Project No. 1339-351-11-02-12
October 18, 2016

Re: Supplemental Submittal
Camelot Landfill Permit Amendment Application – Denton County
Municipal Solid Waste (MSW) Permit No. 1312B
CN600131676/RN101479038

**CAMELOT LANDFILL
CITY OF LEWISVILLE, DENTON COUNTY
TCEQ PERMIT NO. MSW-1312B**

MAJOR PERMIT AMENDMENT APPLICATION

SHEET IIIA-A.16

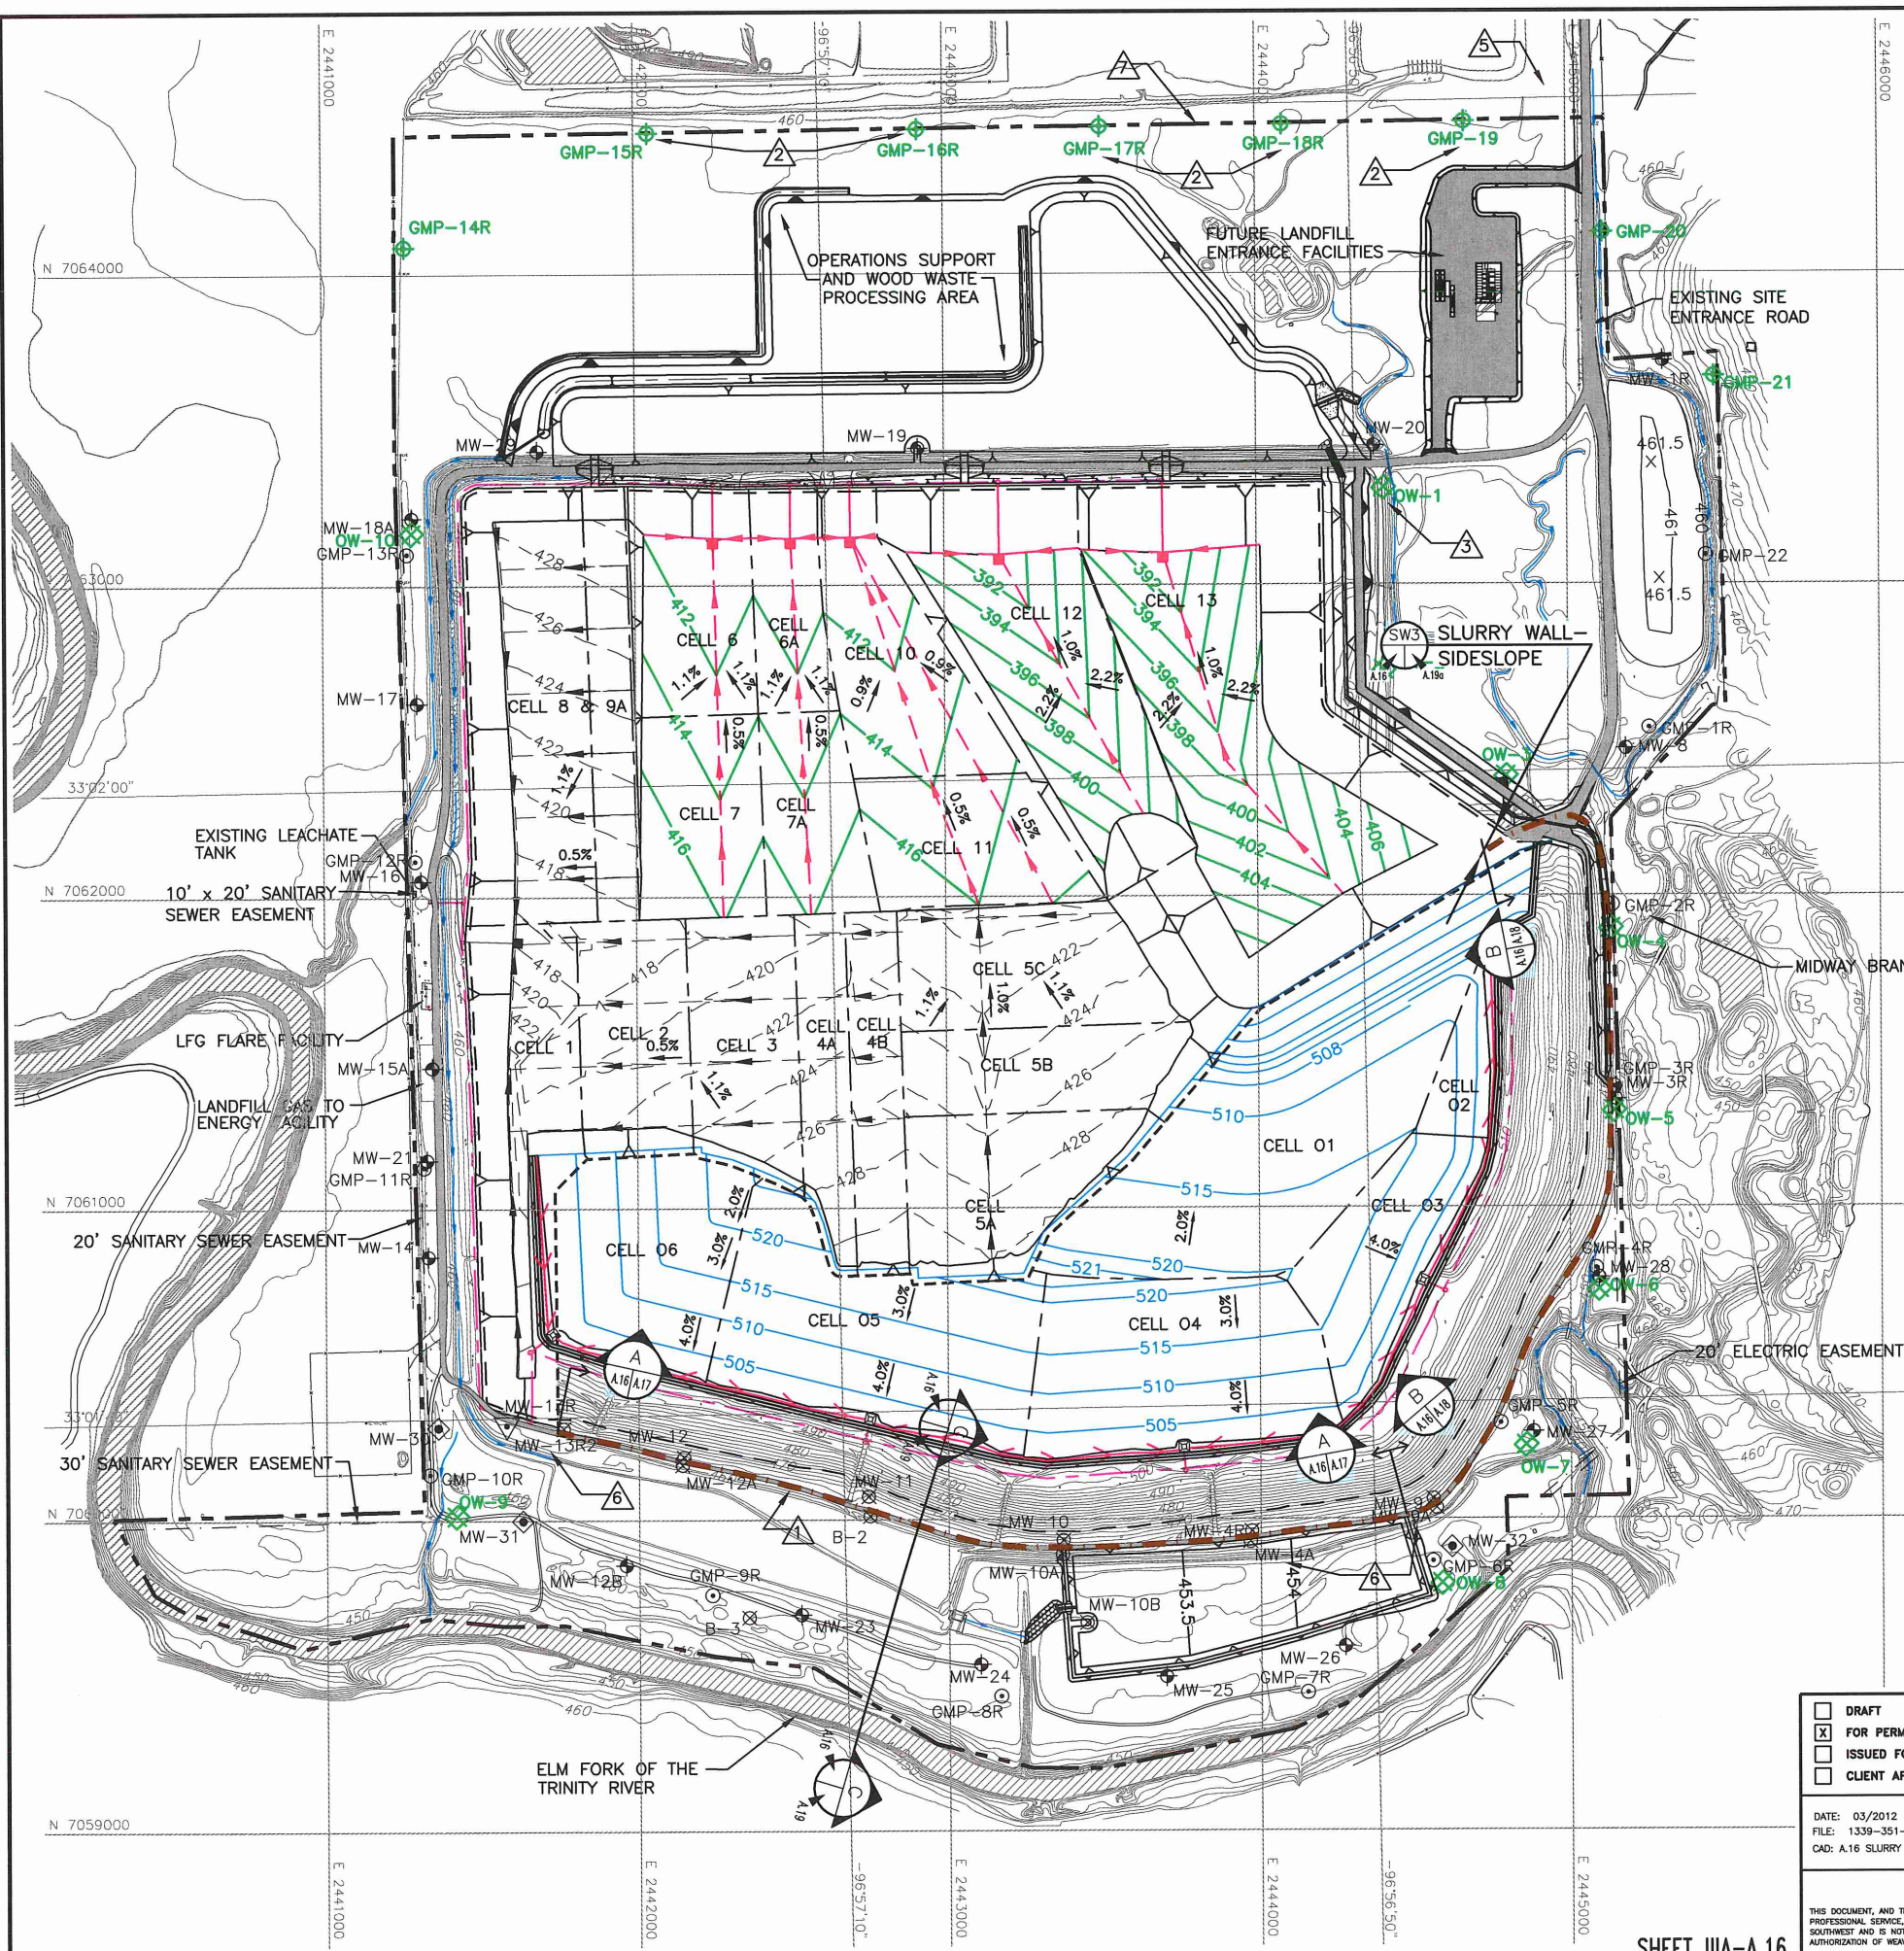
- LIST OF REVISIONS:**
1. REVISED SLURRY WALL TO EXISTING LOCATION.
 2. UPDATED LOCATION OF GAS MONITORING PROBES.
 3. ADDED PROPOSED MONITOR WELLS OW-1 THROUGH OW-10.
 4. REVISED NOTE 3.
 5. REMOVED EASEMENTS.
 6. UPDATED GROUNDWATER MONITORING WELLS WITH AS-BUILT LOCATIONS.
 7. UPDATED PERMIT BOUNDARY INFORMATION.
